**JOINT REGIONAL PLANNING PANEL
(Sydney East Region)**

JRPP No	2014SYE069
DA Number	DA.292/13/2
Local Government Area	North Sydney
Proposed Development	To modify consent No.292/13 so that development consists of demolition of existing structures and the construction of a mixed use development comprising: basement and ground floor retail/commercial uses; residential apartments; communal facilities (including rooftop deck and entertaining spaces); excavation and construction of basement for building services, storage, car parking, motorcycle parking and bicycle parking and associated public domain and landscape works. The proposed modifications will see a change in the mix of the residential unit component to provide for a total of 211 apartments.
Street Address	225-235 Pacific Highway North Sydney
Applicant/Owner	Greenland (Sydney) Pacific Highway Development Pty Ltd
Number of Submissions	One (1)
Report by	Geoff Mossemenear, Executive Planner, North Sydney Council

Assessment Report and Recommendation

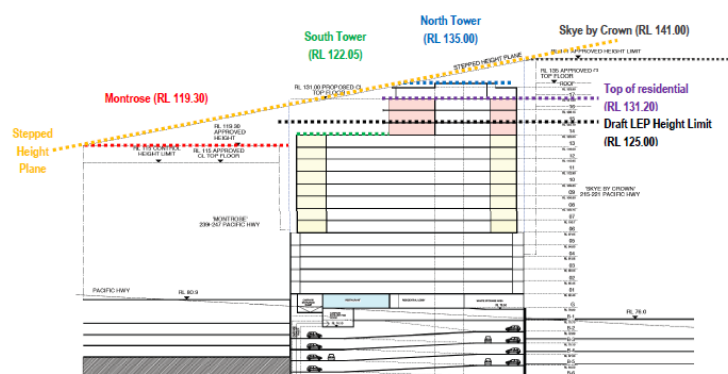
Key to this is the stepped nature of the building and the fact that only the south tower component exceed the height limit with a maximum height of RL135.1. It is noted that the northern tower sits approximately 3m below the LEP height limit of RL 125. When viewed from ground level will have little if any adverse visual or environmental effect.

The northern tower of the proposed building sits 2.95m below the maximum height, while the southern tower exceeds the LEP height limit by 10.1m. Whilst this is the case the building form is a deliberate design strategy that seeks to provide an appropriate transition down in height from Skye to the south, to the Montrose building to the north.

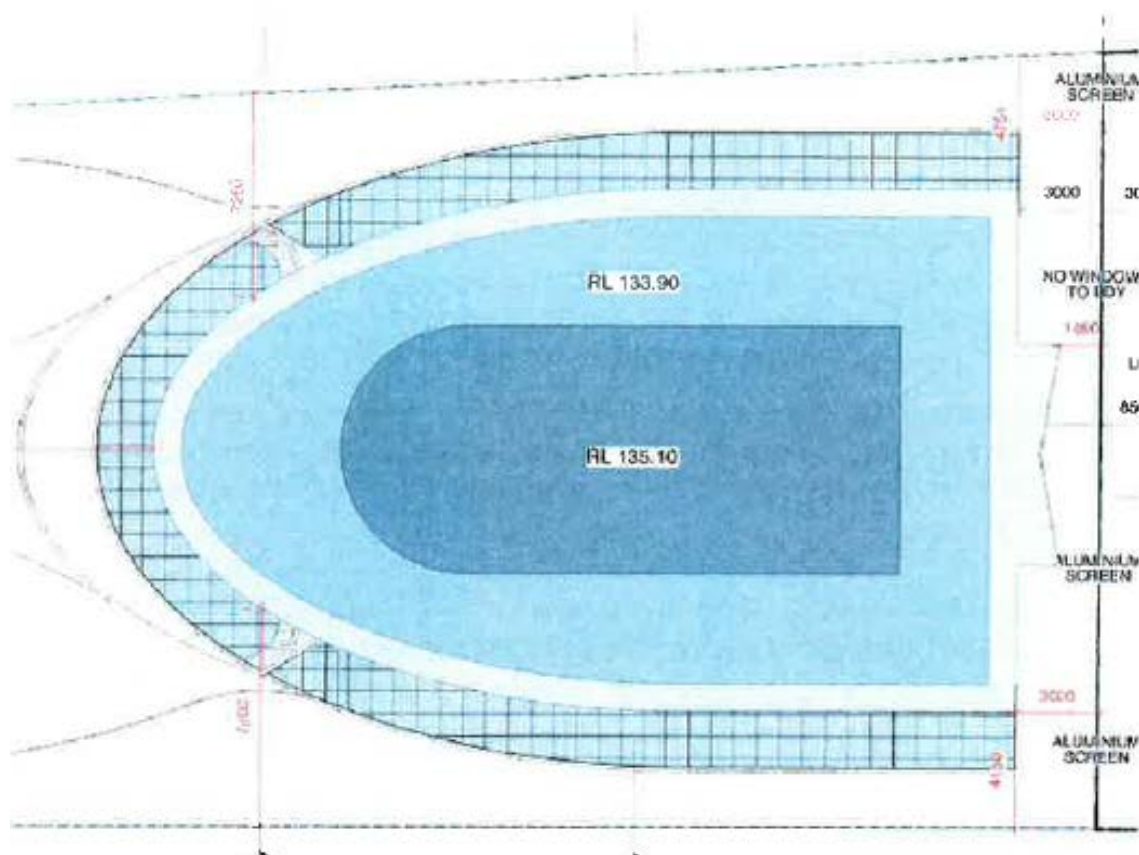
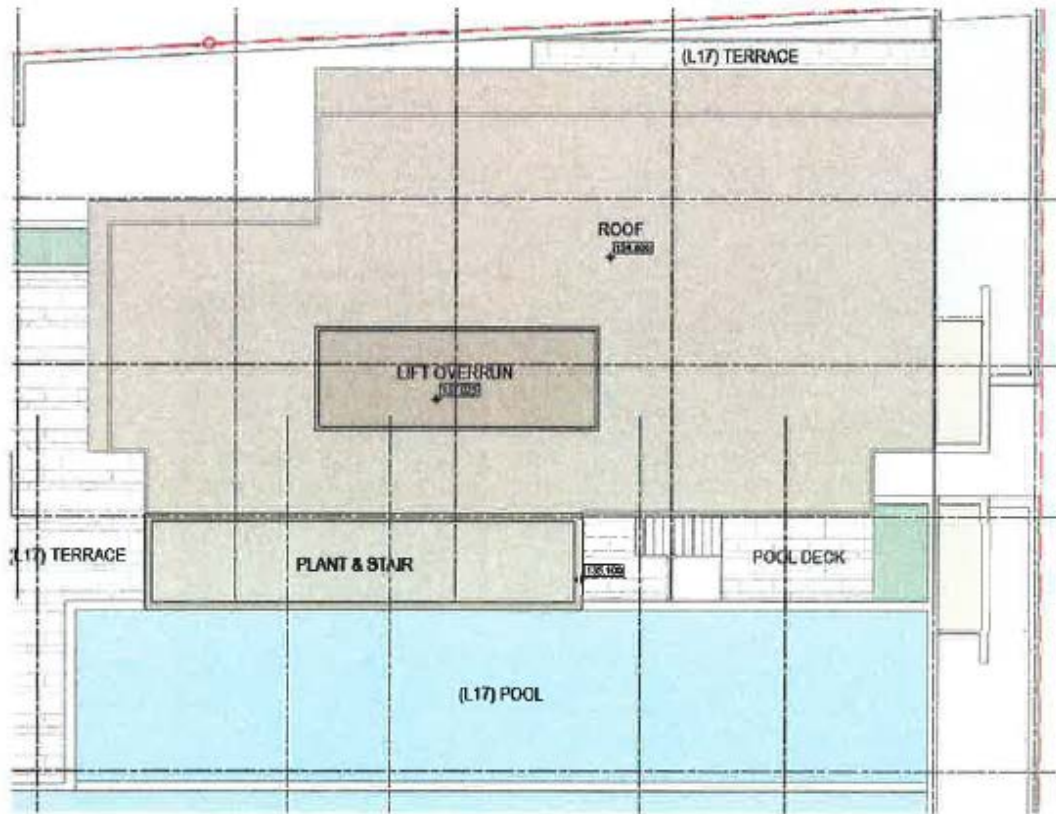
The approved development currently has upper roof height of predominantly RL133.90, with the centre of the top floor rising to RL 135.10. This is shown below:

The proposed building varies these heights slightly, but will ultimately result in less building massing on the top storey.

- A small portion of the roof, namely the lift overrun, extends to RL137.025. Details have been submitted indicating that it was not possible for the lift overrun to be accommodated within RL135.10
- The western side of the roof level, which accommodates the gym, plant and multi-purpose room, will extend to RL134.600, 700mm above the approved height in this area. This increased height will ensure that amenity in the gym and multi-purpose room are maintained to an appropriate level.
- Due to the provision of a pool and barbecue area on the northern and western side of building, these areas are no longer roofed. This results in a significantly smaller built area on the rooftop; the roofed area has been reduced from 670.86m² to 356.43m².
